Service Bulletin RU_SB023

Author: Alexander Gaiderov, Technical Support
Date: 2004-02-03
Subject: GSM Triplets - SEC TMR Display Module
Rating: Level 3 Authorized

Products: V303, V400, V500, V525

Figure 2.0 – Date/Lot Code Identification

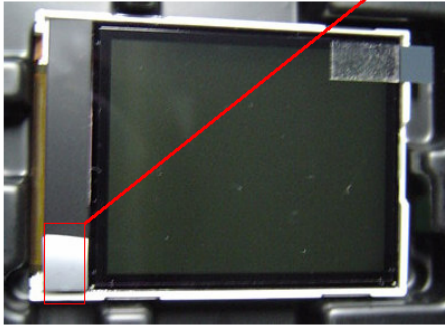
Solution: The original design of the Samsung TMR Display Module (7289238N02) had a high susceptibility to Gate Block failure due the overlapping of the ITO and Data Metal layers. Samsung Changed the design of the TMR Display module, as of November 1st, 2003, to a new mask to separate the ITO and Data Metal layers of the display and strengthen the over-all tolerance against "Gate Block" failure. Samsung TMR Display Modules (7289238N02), built on Line 1 prior to November 1st, 2003, are highly susceptible to this defect. See Figure 2.0 below. Samsung has managed 2 FAB lines and 2 types of 1.88 inch product have been manufactured. In order to identify the FAB code of each product, you have to inspect the red square below picture shown with a micro-scope after detaching the black tape on the driver IC.

***Affected Date Code Range: CMH thru CMJ**

All affected date codes of the 7289238N02 Samsung TMR Display Modules should be removed from inventory and quarantined. See Figure 2.0 above for
